## Request for Continued Examination (RCE) Transmittal

Application Number	10/798,693
Filing Date	03/11/2004
First Named Inventor	Stanton
Art Unit	3673
Examiner Name	LEE
Attorney Docket Number	CLPS-18789

RESPONSE TO OFFICE ACTION DATED JUNE 10, 2009

# REPLACEMENT DRAWINGS

FIG. 4

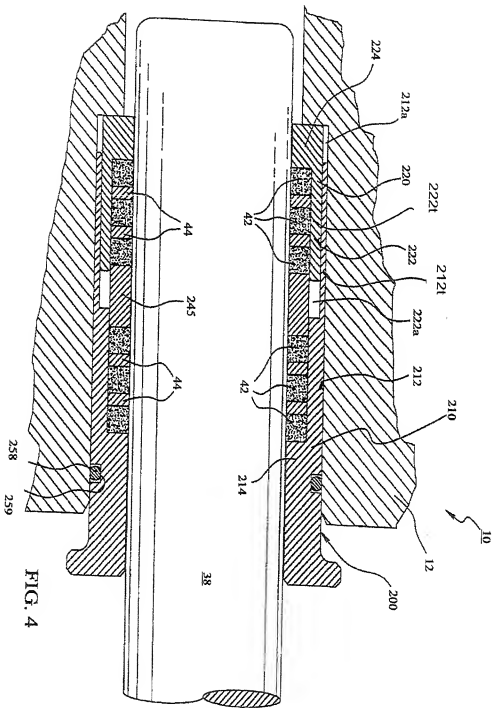
[0145] As will be appreciated, the telescoping structures 212t and 222t of the first sleeve portion **212** and the second sleeve portion **222** allow for squeezing of the first abutment ring **214** and the second abutment ring **224** co-axially closer to one another after positioning the pre-assembled packing cartridge **200** on a plunger **38** in the packing bore **28**. This axial squeezing is initially provided by the gland nut **32** (not shown in **Figure 4**). The gland nut initially can be tightened to the specifications of the packing elements **42**. In addition, from time to time, the gland nut can be tightened further to further squeeze the packing elements **42** in compensation for wear during operation of the pump. Preferably, these telescoping structures 212t and 222t allow for at least sufficient overlapping travel in areas **212a** and **222a** to allow for the expected crushing of packing during the operation of a plunger **38** though the packing cartridge **200**. For example, the expected crush of the packing rings may be about 0.4 inches.

[0146] Preferably, a spacer ring **245** is positioned operatively to cover the overlapping travel of inwardly exposed area **222a** of the telescoping structures 212t and 222t between the first and second sleeve portions **210** and **220**. This spacer ring **245** helps prevent seepage of fluid into any clearances between the first sleeve portion **210** and the second sleeve portion **220**. The spacer ring **245** can also act as a back-up ring for the packing rings **42**.

Regarding Figure 4, Paragraphs 0145 and 0146 of the specification are amended to include the specific references 212t and 222t for the “telescoping structures” and Figure 4 of the drawing is amended to include these references. Further support for these amendments is found in the specification, for example, in Paragraph 0145:

FIG. 6

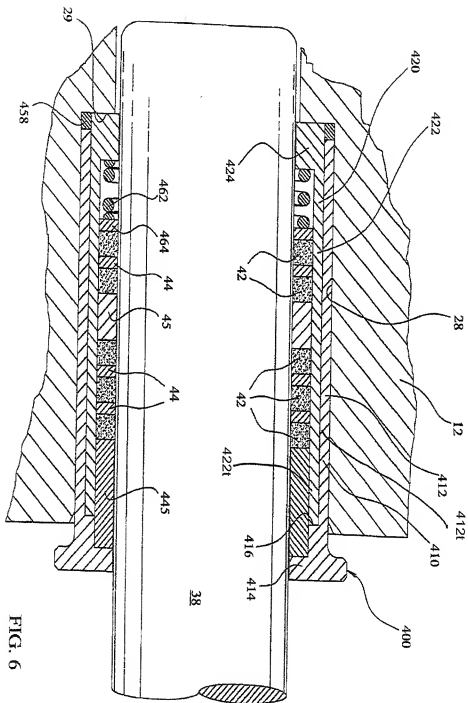
[0156] Preferably, a spacer ring **445** is positioned operatively to cover the overlapping travel of the telescoping structures 422t and 412t between the first and second sleeve portions **410** and **420**. This spacer ring **445** helps prevent seepage of fluid into any clearances between the first sleeve portion **410** and the second sleeve portion **420**. The spacer ring **445** can also act as a back-up ring for the packing rings **42**.

[0158] As will be appreciated, the telescoping structures 422t and 412t of the first sleeve portion **412** and the second sleeve portion **422** allow for squeezing of the first abutment ring **414** and the second abutment ring **424** co-axially closer to one another after positioning the pre-assembled packing cartridge **400** on a plunger **38** in the packing bore **28**. However, in this embodiment, the packing cartridge **400** is positioned in the packing bore **28** and tightened by a gland nut (not shown) until the second sleeve portion **422** bottoms out against a shoulder **416** of the first sleeve portion **412**. In this position, the coil spring **462** is compressed with a packing assembly positioned between the first abutment ring **414** and a second abutment ring **424**. The advantage of bottoming out the telescoping structures 422t and 412t is that it prevents over-tightening of the packing cartridge **400** in the packing bore **28**. The spring **462** maintains a pre-determined amount of axial compression on the packing rings **42** of the packing stack.

Regarding Figures 6 and 12, Paragraphs 0156 and 0158 of the specification are amended to include the specific references 412t and 422t for the “telescoping structures” and Figures 6 and 12 of the drawing is amended to include these references. Figure 12 is a cross-sectional view of another embodiment of a packing cartridge similar to the embodiment shown in Figure 7 (*See, e.g.*, Specification Paragraphs 0076 and 0193), where Figure 7 is a cross-sectional view of another embodiment of a packing cartridge similar to the embodiment shown in Figure 6 (*See, e.g.*, Specification Paragraphs 0068 and
